Access Compliance Report

Public Rights-of-Way

Intersection ID: 29283	Main Street: CLOONEY_LN	Cross Street: OLD_ROBINSON_TL	Location: N
ADA ID: F00DD455FA1C	Ramp Type: PerpDiag	Initial Pass/Fail: Fail	Overall Compliance: No
Severity Score: 33.75			
Codes/Mitigation Info/Possible Solution		Field Measurements/Component Compliance

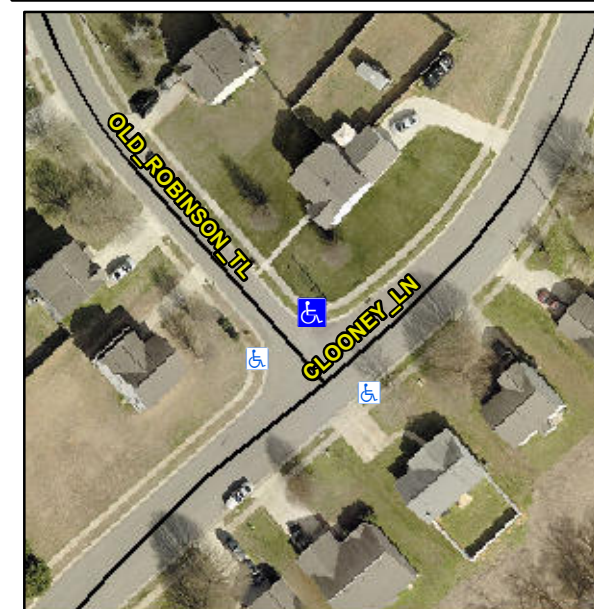
Not Found, R304.5.1, R304.5.3

Compliance	Description	Data	Compliance	Description	Data
N/A	Ramp Length (in)	48.0	Yes	Ramp Slope (%)	7.1
No	Ramp Width (in)	37.0	No	Ramp XSlope (%)	8.7
N/A	Flare Type LT	N/A	N/A	Flare Type RT	N/A
N/A	Flare Slope LT (%)	N/A	N/A	Flare Slope RT (%)	N/A
N/A	Flare Traversable LT?	N/A	N/A	Flare Traversable RT?	N/A
N/A	Landing Length (in)	N/A	N/A	DWS Provided?	N/A
N/A	Landing Width (in)	N/A	N/A	DWS Contrast?	N/A
N/A	Landing Slope (%)	N/A	N/A	DWS Length (in)	N/A
N/A	Landing X Slope (%)	N/A	N/A	DWS Full Width?	N/A
N/A	Landing Curb? (Y/N)	N/A	N/A	DWS Offset (in)	N/A
N/A	Shared Landing?	N/A			
N/A	Gutter Ponding?	N/A	N/A	Gutter Slope (%)	N/A
N/A	Gutter Lip Ht (in)	1.0	N/A	Gutter X Slope (%)	N/A
N/A	Painted X Walk1?	No	N/A	Painted X Walk2?	No
	X Walk 1 Direction	To SW		X Walk 2 Direction	To SE
N/A	X Walk 1 Width (in)	N/A	N/A	X Walk 2 Width (in)	N/A
	X Walk 1 Slope (%)	7.7		X Walk 2 Slope (%)	0.2
	X Walk 1 X Slope (%)	6.7		X Walk 2 X Slope (%)	4.1

N/A	Ramp inside XWalk1?	N/A	N/A	Ramp inside XWalk2?	N/A
	Road Slope (%)	7.3	N/A	Clear Space?	N/A
	Road X Slope (%)	3.1	N/A	Clear Space to XWalk (in)	N/A
N/A	Any Obstructions?	N/A	N/A	Storm Grate/Utility Hazard?	N/A
	Obstruction Type			Storm Grate/Utility Type	
		N/A			N/A
		Yes		Surface Condition? (G/P)	Good

Remove & Replace Curb Ramp With Two New Directional Ramps or Equivalent.
